## Changes to proposed District Map Amendment G-956

A revised version of DMA G-956, dated April 18, 2014, has been posted on the Planning Department website for review. It contains all of the proposed and approved changes that have occurred since March 7, 2014. The following document illustrates all of the changes to DMA G-956.

Changes made to DMA G-956 are organized into two sections, each section describing a different type of revision.

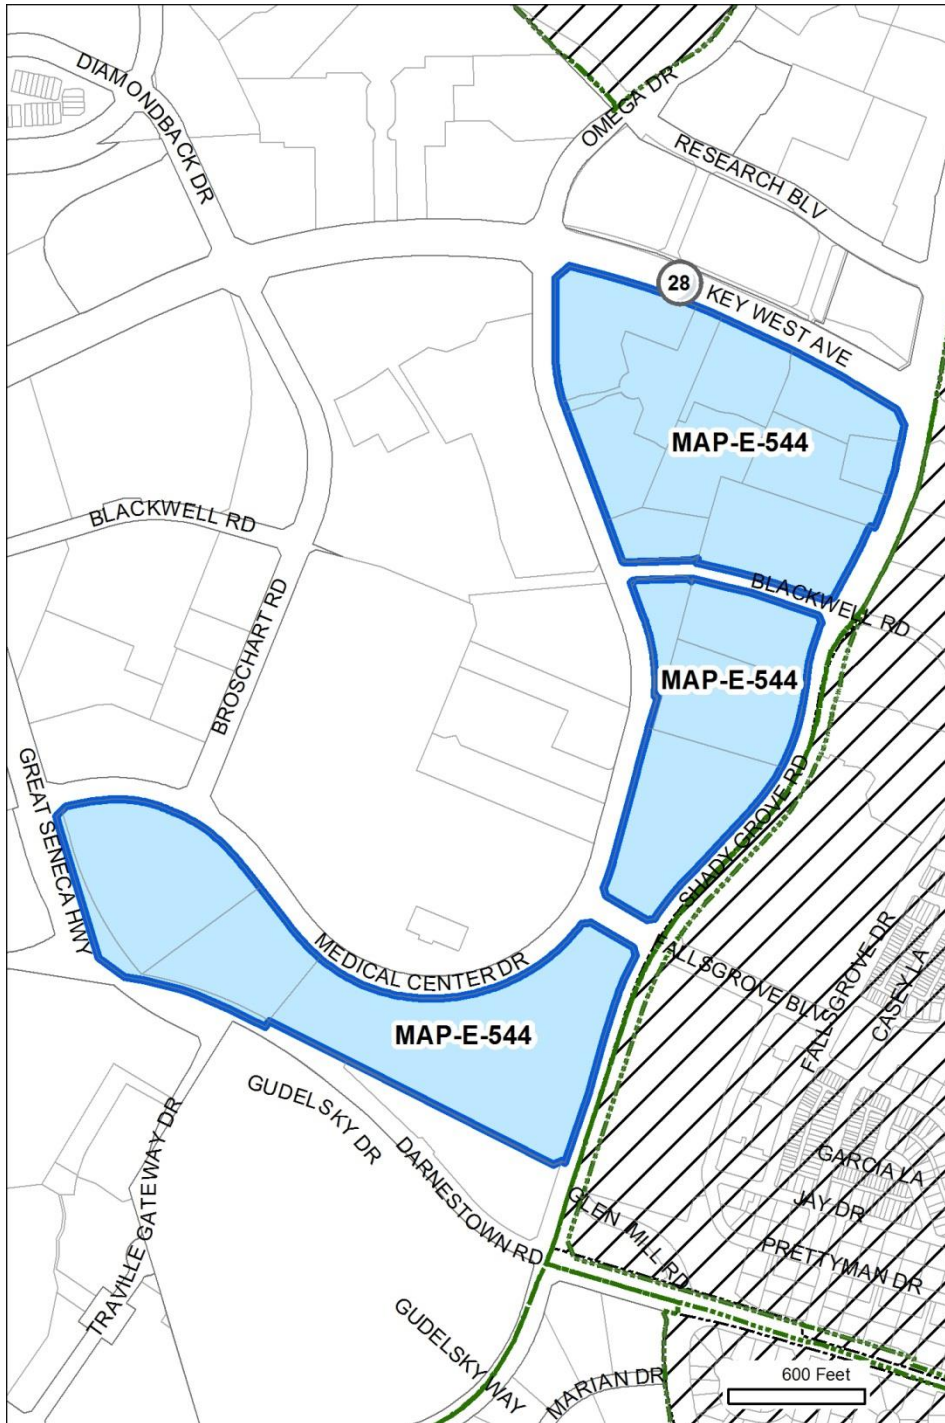
Unique ID: MAP-E-543B		staff error
Master Plan ID: GSSCR-04		
Master Plan:	Great Seneca Science Corridor	
Location:		
Existing Zone:	LSC	
Proposed Conv: (3/7)	LSC-1.0 H-150	
Prop. Revised Conv:	LSC-1.0 H-150 T	
Category:	Error	
Modifications	Zone Group:	No change
	Overall FAR:	No change
	Comm'l FAR:	No change
	Resid'l FAR:	No change
	Height:	No change
Reason for change:		
<p><i>The LSC zone allows bonus density for the provision of additional MPDUs under Chapter 25A.</i></p> <p><i>This zone should have been given the "T" at the end of the formula to indicate that it is eligible for the MPDU density bonus.</i></p>

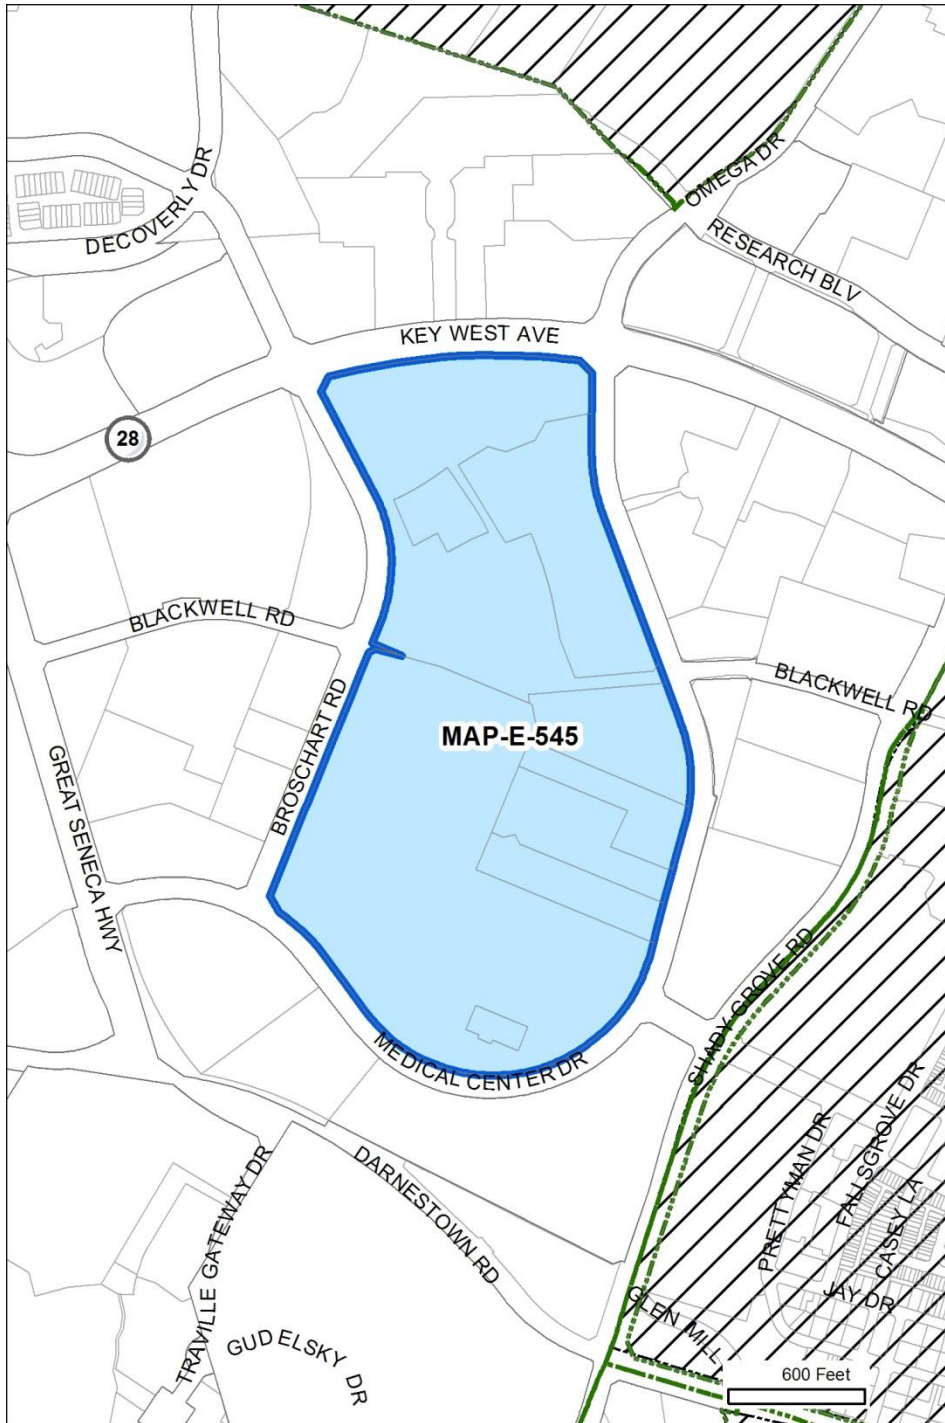
Unique ID: MAP-E-544		staff error
Master Plan ID: GSSCR-03		
Master Plan:	Great Seneca Science Corridor	
Location:		
Existing Zone:	LSC	
Proposed Conv: (3/7)	LSC-1.0 H-110	
Prop. Revised Conv:	LSC-1.0 H-110 T	
Category:	Error	
Modifications	Zone Group:	No change
	Overall FAR:	No change
	Comm'l FAR:	No change
	Resid'l FAR:	No change
	Height:	No change
<b>Reason for change:</b>		
<p><i>The LSC zone allows bonus density for the provision of additional MPDUs under Chapter 25A.</i></p> <p><i>This zone should have been given the "T" at the end of the formula to indicate that it is eligible for the MPDU density bonus.</i></p>

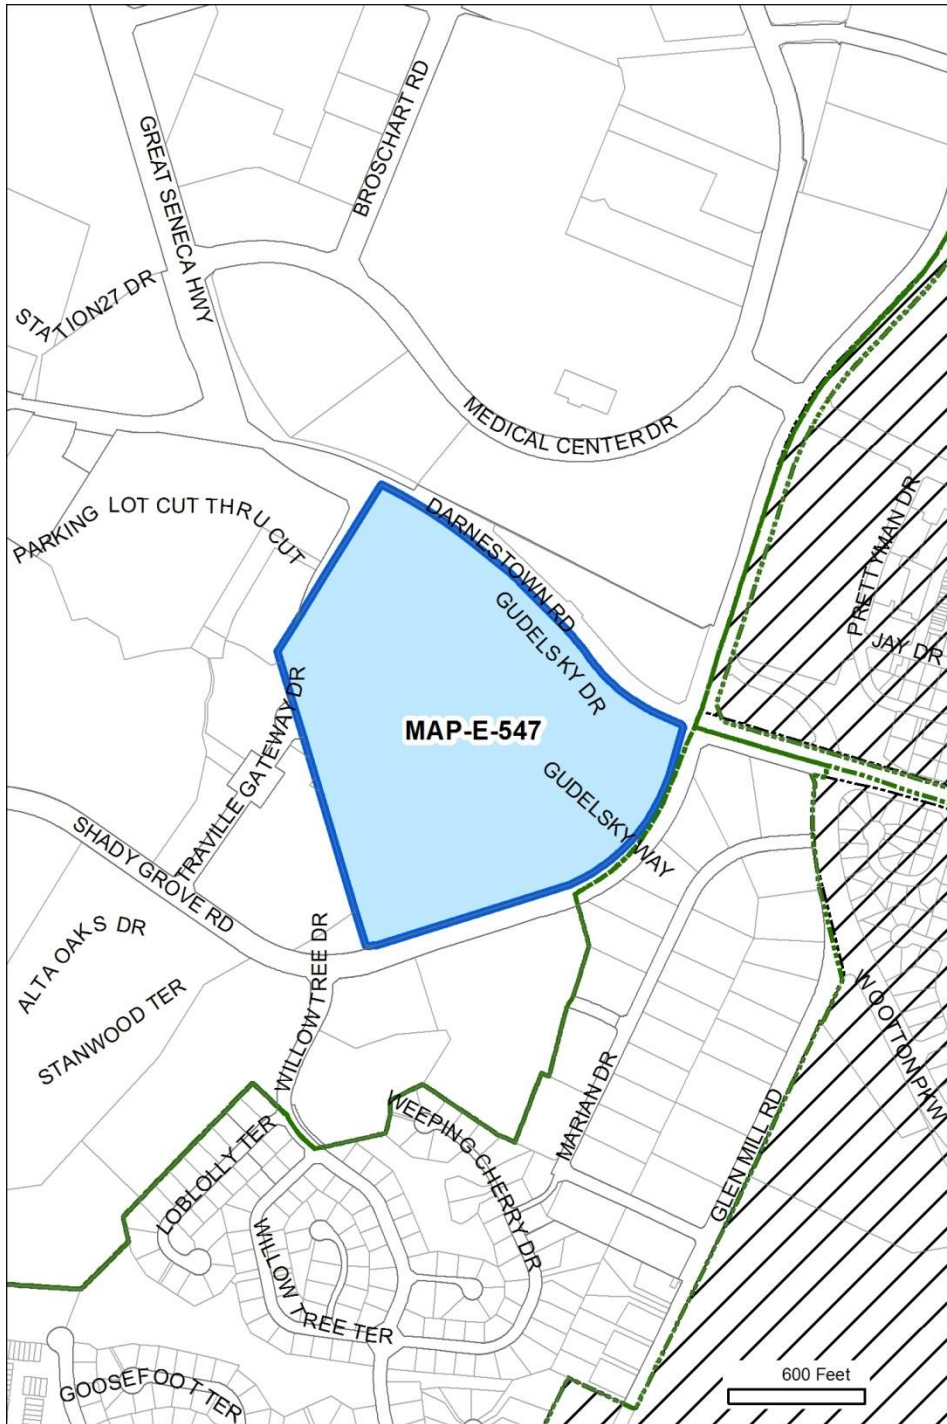
Unique ID: MAP-E-546		staff error
Master Plan ID: GRMTC-26		
Master Plan:		Germantown Town Center
Location:		
Existing Zone:		LSC
Proposed Conv: (3/7)		LSC-2.0 H-100
Prop. Revised Conv:		LSC-2.0 H-100 T
Category:		Error
Modifications	Zone Group:	No change
	Overall FAR:	No change
	Comm'l FAR:	No change
	Resid'l FAR:	No change
	Height:	No change
Reason for change:		
<p><i>The LSC zone allows bonus density for the provision of additional MPDUs under Chapter 25A.</i></p> <p><i>This zone should have been given the "T" at the end of the formula to indicate that it is eligible for the MPDU density bonus.</i></p>

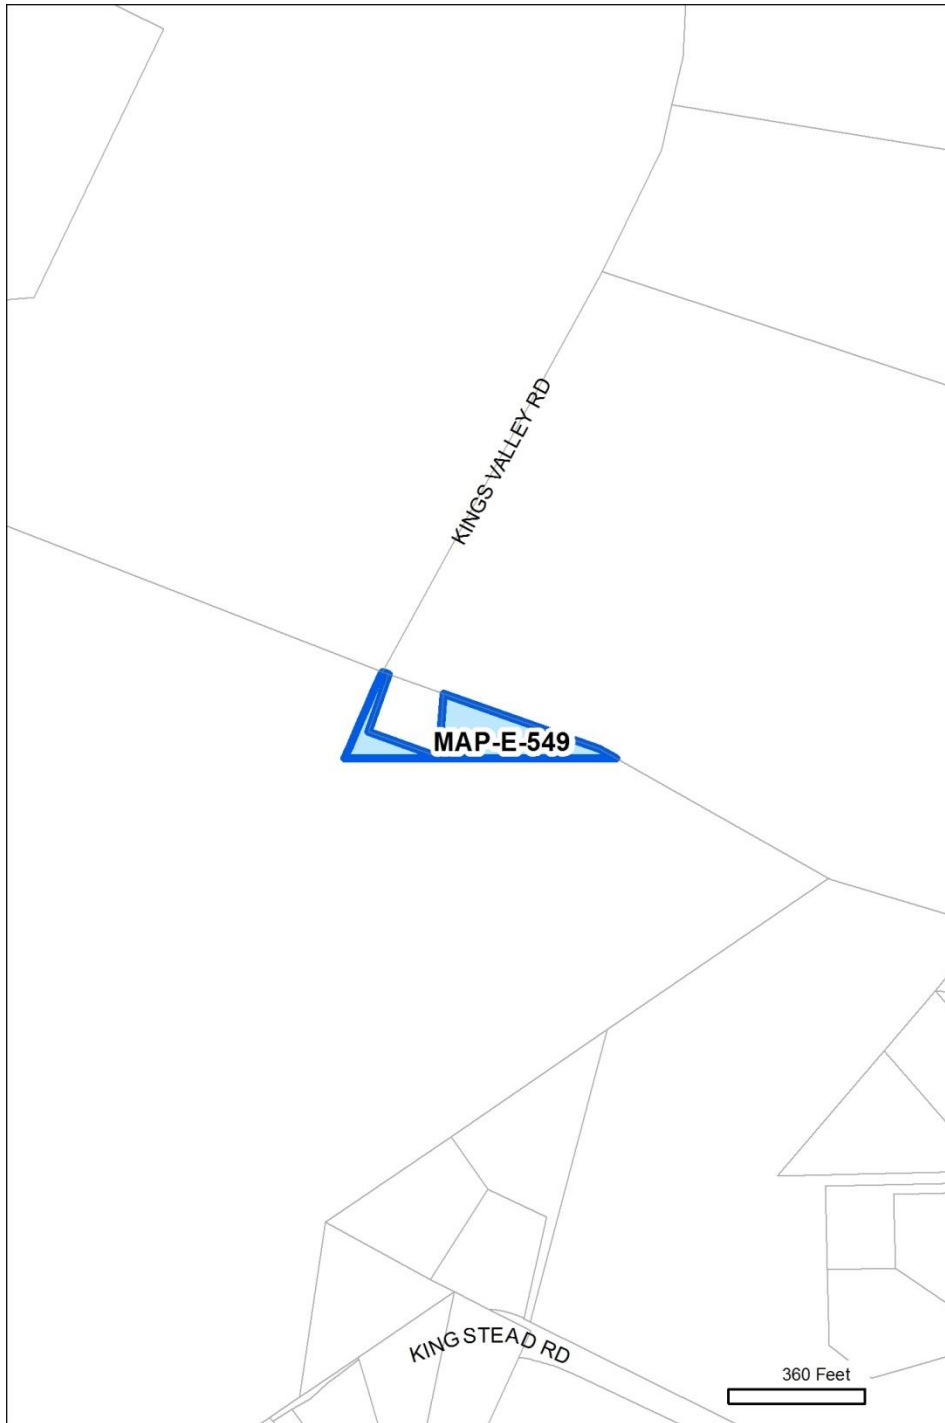
Unique ID: MAP-E-548		staff error
Master Plan ID: BTHDA-40		
Master Plan:	Bethesda CBD	
Location:		
Existing Zone:	CBD-2	
Proposed Conv: (3/7)	CR-5.0 C-4.0 R-4.75 H-145 T	
Prop. Revised Conv:	CR-5.0 C-5.0 R-4.75 H-145 T	
Category:	Error	
Modifications	Zone Group:	No change
	Overall FAR:	No change
	Comm'l FAR:	Increased to 5.0
	Resid'l FAR:	No change
	Height:	No change
<b>Reason for change:</b>		
<p><i>These properties are part of a development approval which allows additional commercial FAR up to 5.0 (under a footnote in the CBD-2 zone). The PHED discussed this issue and approved the change. However these properties were inadvertently left out of the change. They should have been included in the change <b>MAP-E-207</b>.</i></p> <p><i>As a result, staff is proposing to increase the commercial FAR to 5.0 to match the approvals on the rest of the site.</i></p>

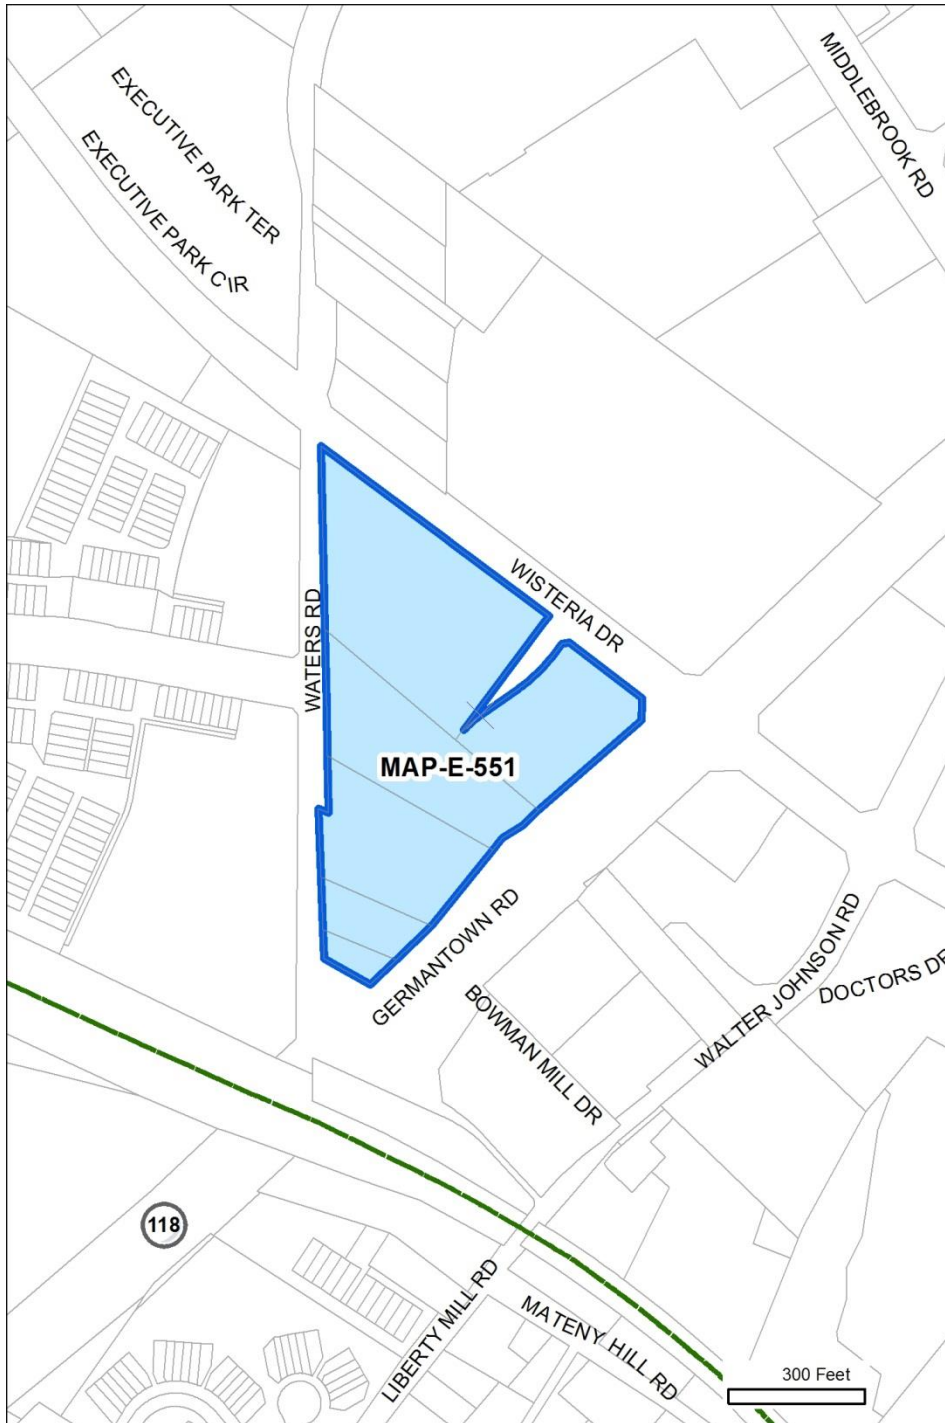
<b>Unique ID:</b> MAP-E-550		staff error
<b>Master Plan ID:</b> POTMC-04		
<b>Master Plan:</b>	Potomac Subregion	
<b>Location:</b>		
<b>Existing Zone:</b>	RMX-2C	
<b>Proposed Conv:</b> (3/7)	CRT-0.75 C-0.5 R-0.5 H-35 T	
<b>Prop. Revised Conv:</b>	CRT-0.75 C-0.5 R-0.25 H-35 T	
<b>Category:</b>	Error	
<b>Modifications</b>	<b>Zone Group:</b>	No change
	<b>Overall FAR:</b>	No change
	<b>Comm'l FAR:</b>	No change
	<b>Resid'l FAR:</b>	Reduced to 0.25
	<b>Height:</b>	No change
<b>Reason for change:</b>		
<p><i>The master plan calls for a total of 135 residential units. Of that total, 40 are to be townhouses. The remaining 95 are to be multi-family units.</i></p> <p><i>Given the average unit sizes of these, the approximate FAR of that development would be approximately 0.22 FAR.</i></p> <p><i>Therefore, staff feels that the Residential FAR should be limited to 0.25 FAR instead.</i></p>

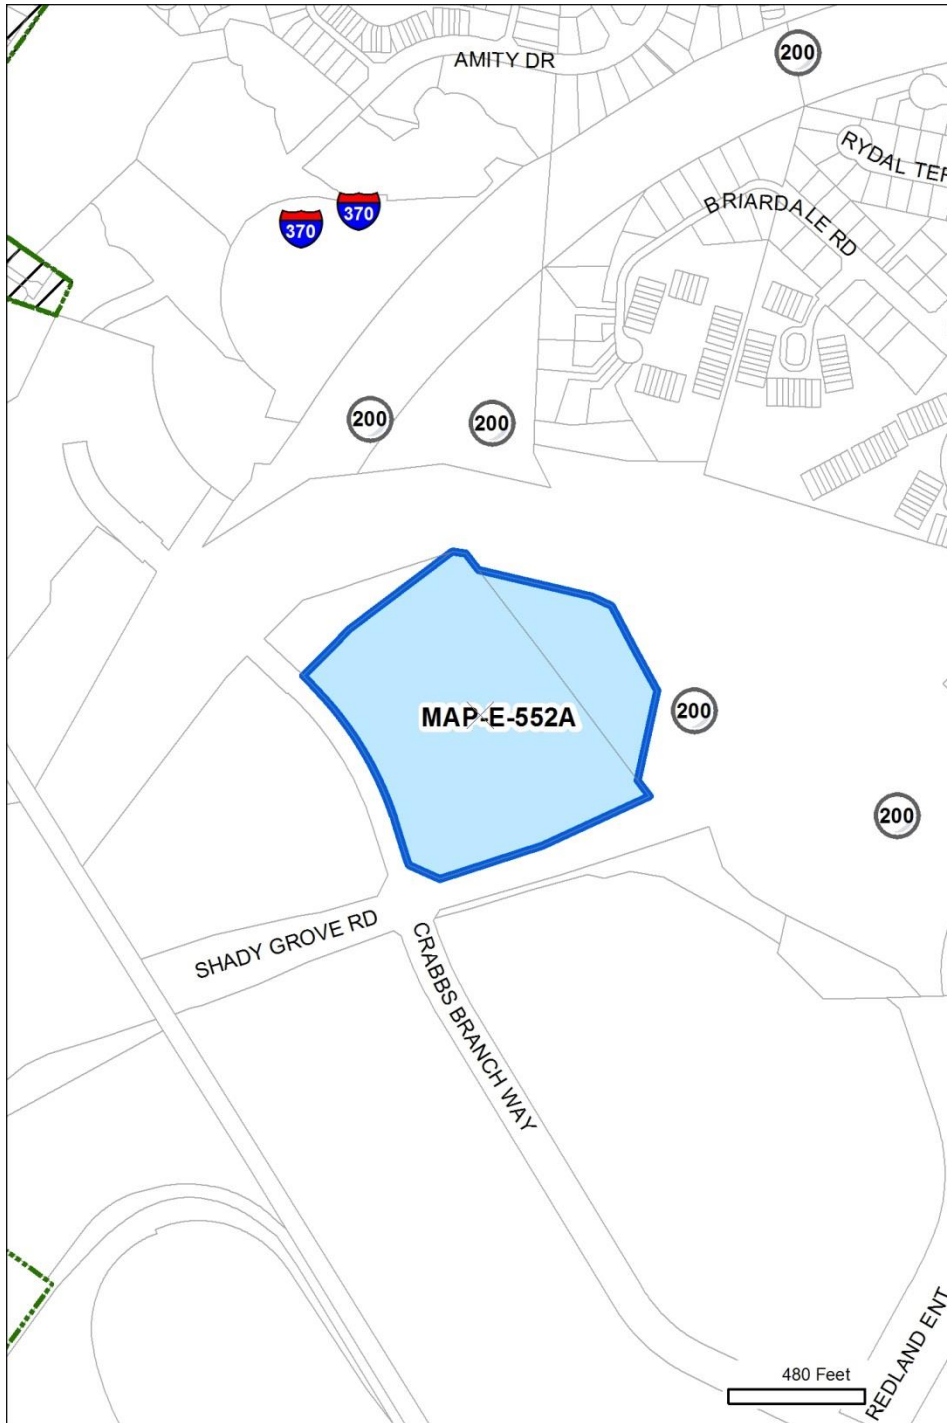
<b>Unique ID:</b> MAP-E-551		staff error
<b>Master Plan ID:</b> GRMTC-19		
<b>Master Plan:</b>	Germantown TC	
<b>Location:</b>		
<b>Existing Zone:</b>	RMX-2C	
<b>Proposed Conv:</b> (3/7)	CRT-1.0 C-0.25 R-0.75 H-65 T	
<b>Prop. Revised Conv:</b>	CRT-1.0 C-0.5 R-0.75 H-65 T	
<b>Category:</b>	Error	
<b>Modifications</b>	<b>Zone Group:</b>	No change
	<b>Overall FAR:</b>	No change
	<b>Comm'l FAR:</b>	Increased to 0.5
	<b>Resid'l FAR:</b>	No change
	<b>Height:</b>	No change
<b>Reason for change:</b>		
<p><i>The master plan calls for allowing up to 220,000 SF of commercial development. On this site, that would be approximately 0.499 FAR.</i></p> <p><i>The commercial FAR shown in the DMA is not enough to accommodate the recommendations of the master plan, so it should be increased to 0.5 FAR.</i></p>
